ADDENDUM

PROJECT: Lincoln Public Schools
Lincoln Northeast High School
Fitness Center Addition
Lincoln, Nebraska

AD-2

DATE ISSUED: Friday, January 8, 2016

SHEET NUMBER
C-104

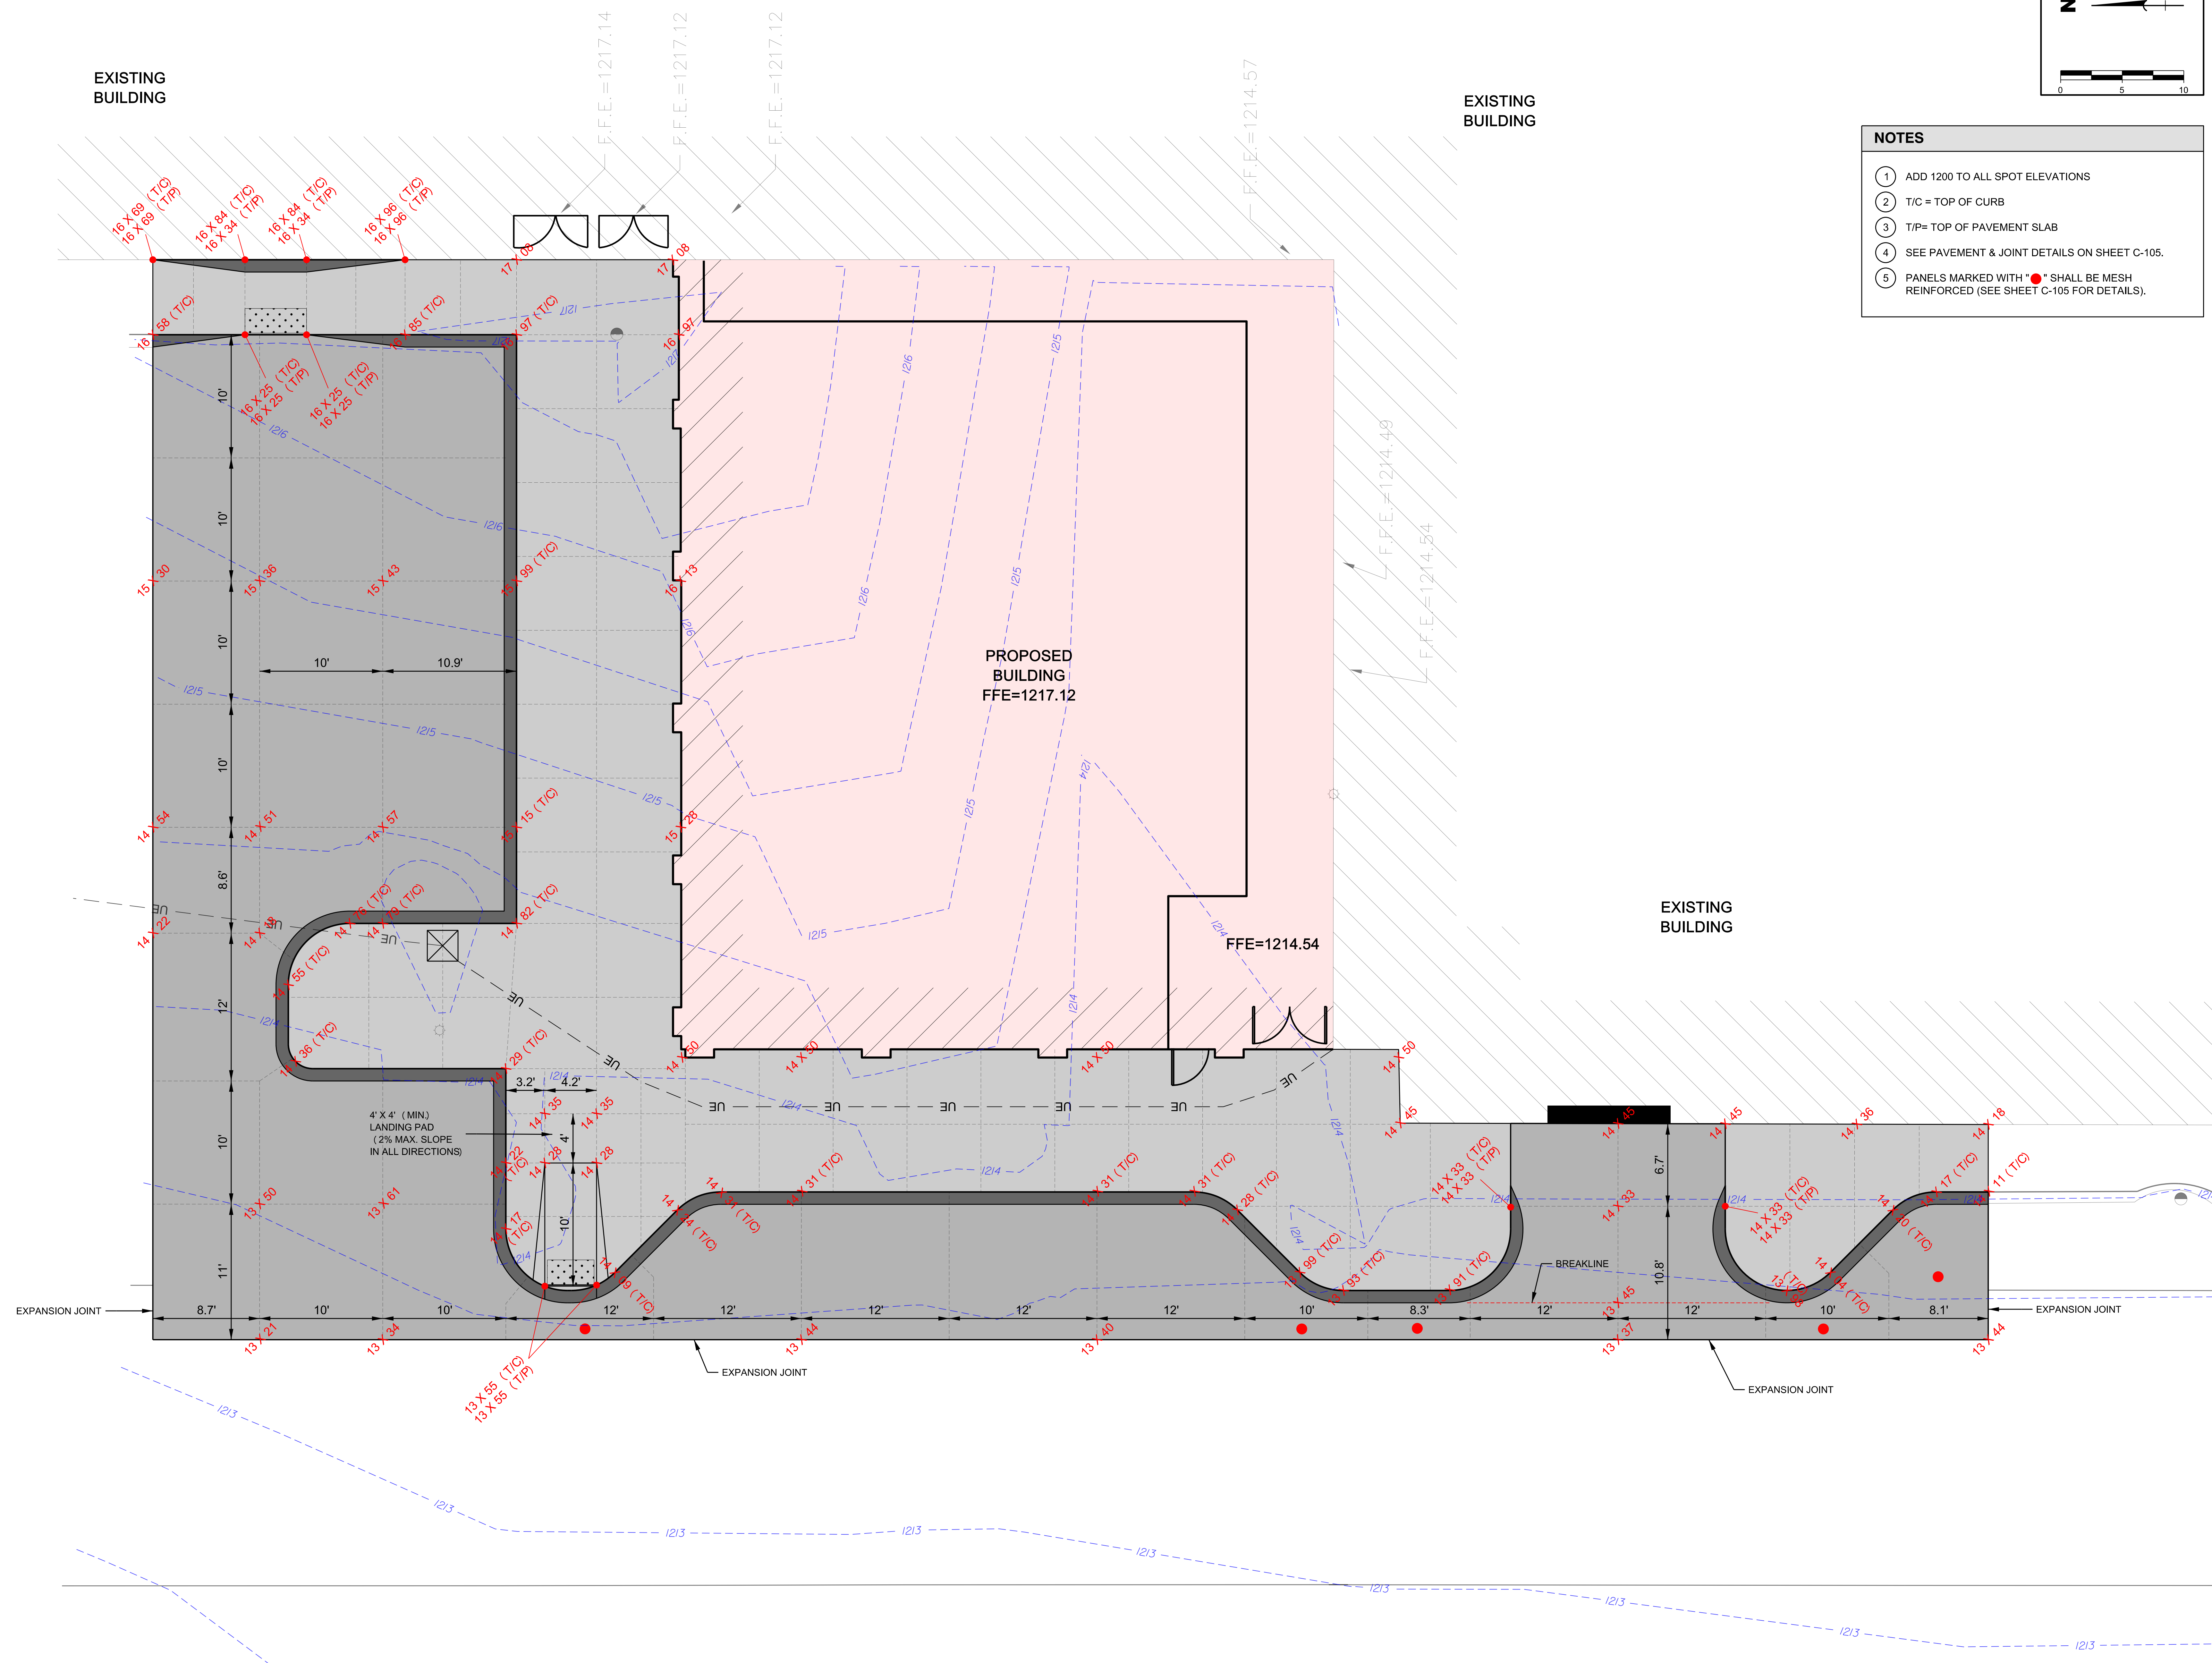
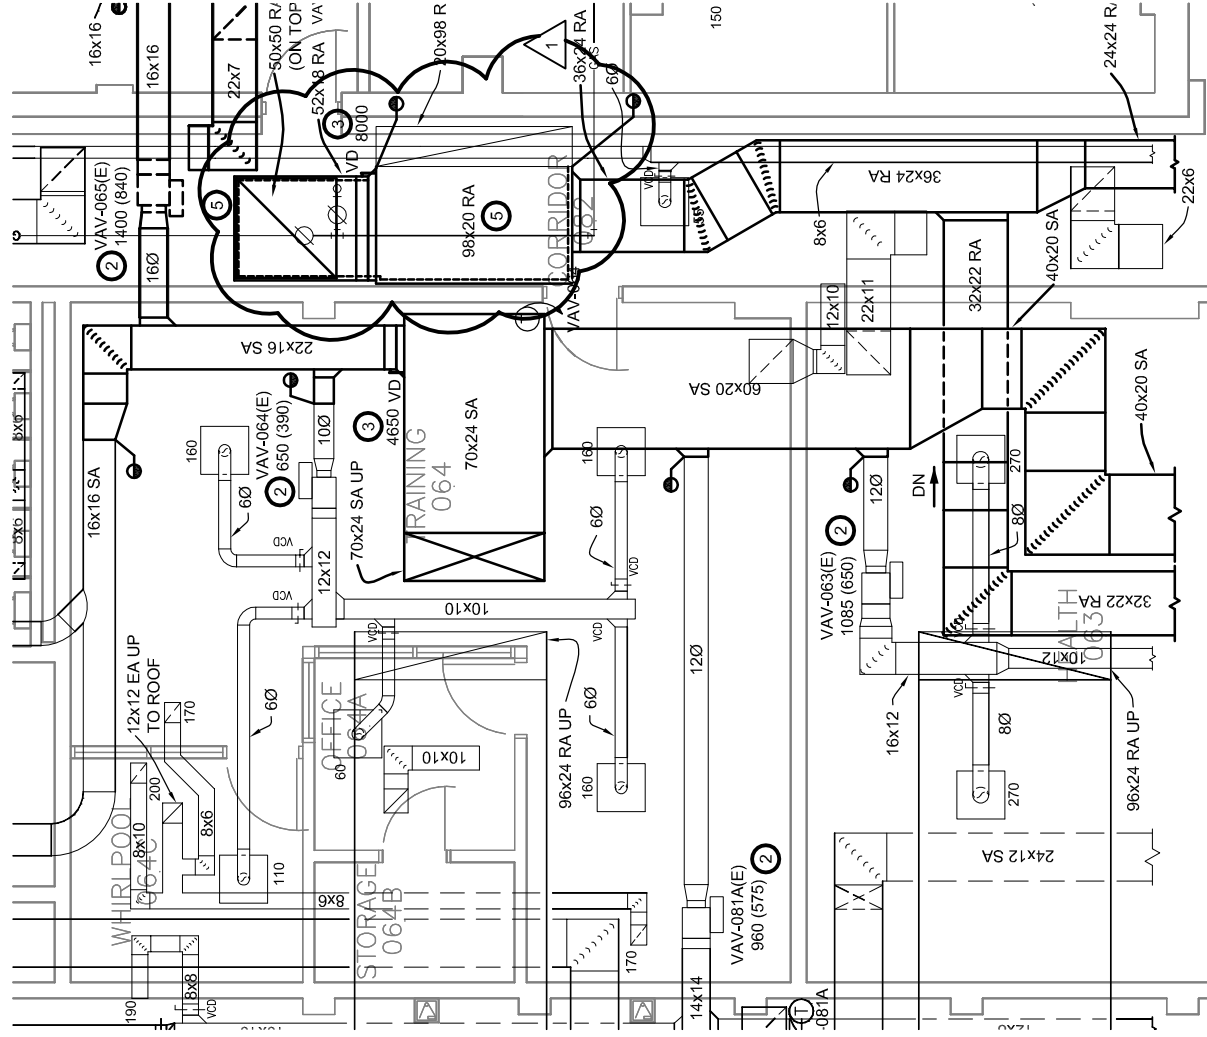
In reference to Sheet C-104, see attached revised sheet.
